Project:	Long Term Water Project – ATCO Loop Decommissioning Request for Tender	RFT No.:	2023-RFT-054
Addendum No.:	06	No. of Pages	1
Date:	June 2, 2023	Doc. No.	P7201-950302569-179(1.0)

Long Term Water Project – ATCO Loop Decommissioning
Addendum No. : 06

2 **SANITARY SERVICE
TRENCH DETAIL**
ADJUST TO BLDG. 243 UMIQ

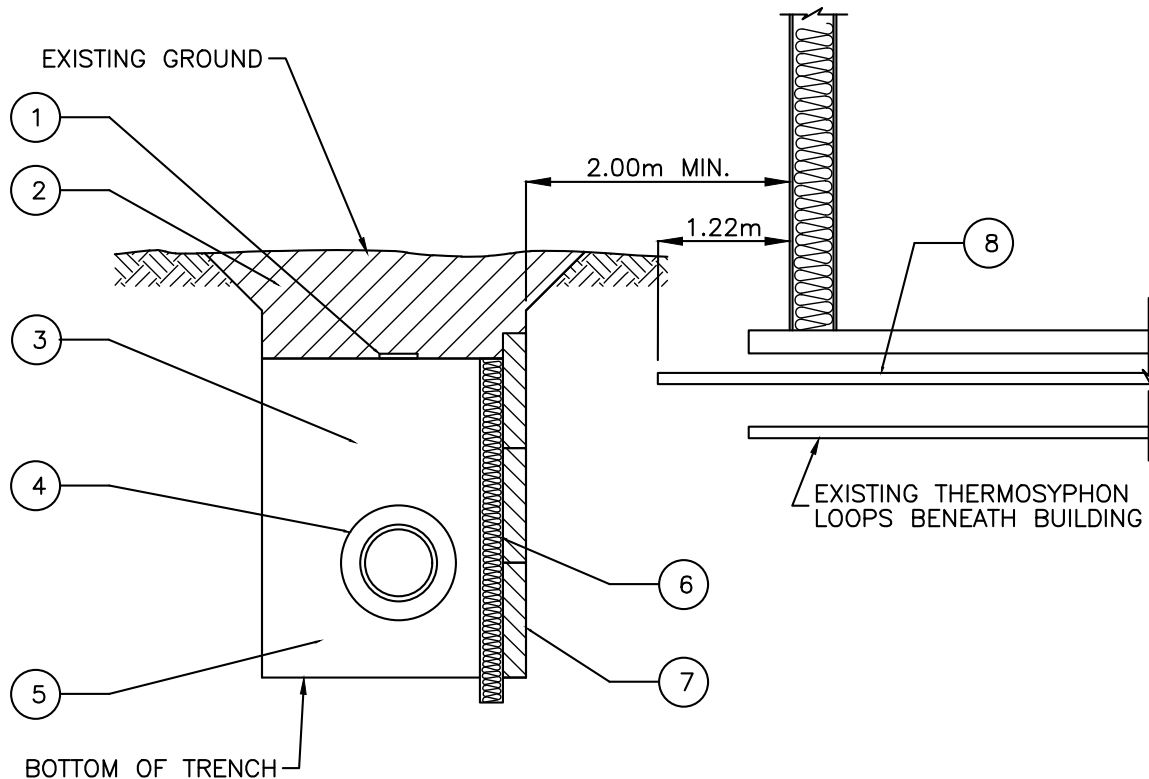
Can you provide a detail or drawing showing the requirements for the additional measures for sewer service installation adjacent du QEC building, 243 Umiag (Point R2.2 of the Addendum 2). It would help visualise what needs to be completed for wood bracing and vertical insulation.

Refer to enclosed cross section detail for the additional measures that will be required for the sewer service installation adjacent to the QEC building.
